SUBJECT: COMANCHE PEAK NUCLEAR POWER PLANT, UNITS 1 AND 2 - STAFF ASSESSMENT OF INFORMATION PROVIDED PURSUANT TO TITLE 10 OF THE *CODE OF FEDERAL REGULATIONS* PART 50, SECTION 50.54(f), SEISMIC HAZARD REEVALUATIONS FOR RECOMMENDATION 2.1 OF THE NEAR-TERM TASK FORCE REVIEW OF INSIGHTS FROM THE FUKUSHIMA DAI-ICHI ACCIDENT AND STAFF CLOSURE OF ACTIVITIES ASSOCIATED WITH RECOMMENDATION 2.1, "SEISMIC" (CAC NOS. MF3937 AND MF3938)

STAFF ASSESSMENT BY THE OFFICE OF NUCLEAR REACTOR REGULATION

RELATED TO SEISMIC HAZARD AND SCREENING REPORT

COMANCHE PEAK NUCLEAR POWER PLANT, UNITS 1 AND 2

Figure 3.3-2 Plot Comparing the Staff's and the License's Median Amplification Functions and Uncertainties for the CPNPP site

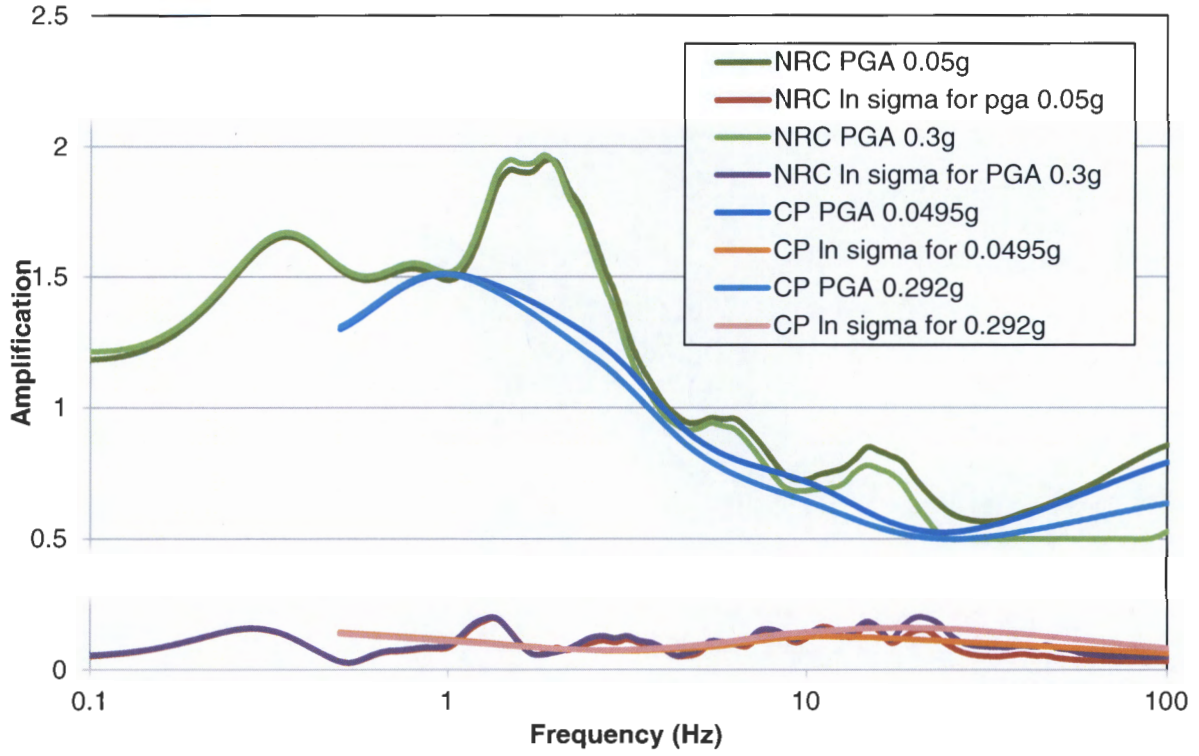
Figure 3.3-2 of this assessment shows a comparison of the NRC staff's and licensee's median site amplification functions and uncertainties (± 1 standard deviation) for 2 of the 11 input loading levels. As shown in Figure 3.3-2, the NRC staff's and licensee's amplification factors follow a similar trend; however, the staff's amplification factors are somewhat larger between 1 to 5 Hz. Figure 3.3-3 of this assessment shows a comparison of the staff's and licensee's control point hazard curves for 1 Hz, 10 Hz and PGA. As shown in Figure 3.3-3, the licensee's control point hazard curves are slightly higher than the NRC staff's curves for these three frequencies. Appendix B of the SPID provides guidance for performing site response analyses, including capturing the uncertainty for sites with less subsurface data; however, the guidance is neither entirely prescriptive nor comprehensive. As such, various approaches in performing site response analyses, including the modeling of uncertainty, are acceptable for the 50.54(f) response.

Figure 3.4-1 Comparison of the Staff's GMRS with Licensee's GMRS and the SSE for the CPNPP site

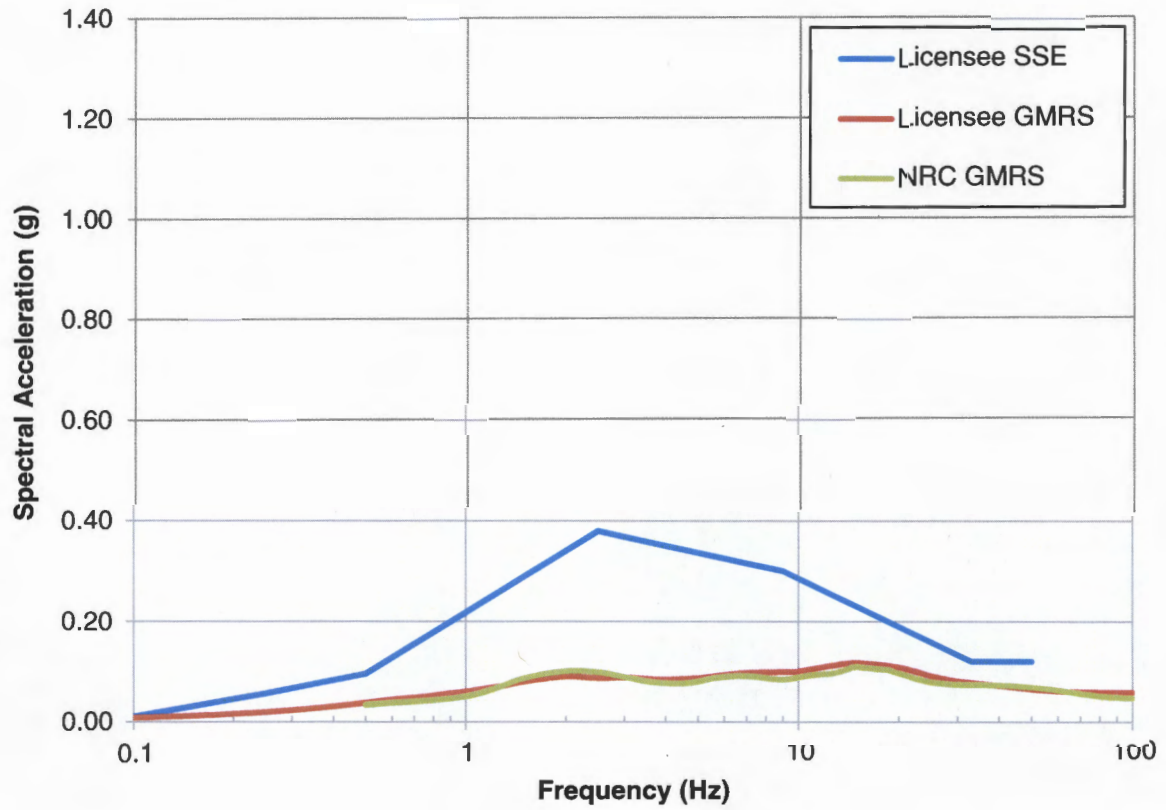
The NRC staff independently calculated the 10^{-4} and 10^{-5} UHRS using the results of its confirmatory PSHA and site response analyses, as described in Sections 3.2 and 3.3 of this staff assessment, respectively. Figure 3.4-1 of this assessment shows a comparison of the GMRS determined by the licensee to that determined by the NRC staff. As shown in Figure 3.4-1, the licensee's GMRS is very similar to the staff's confirmatory GMRS.
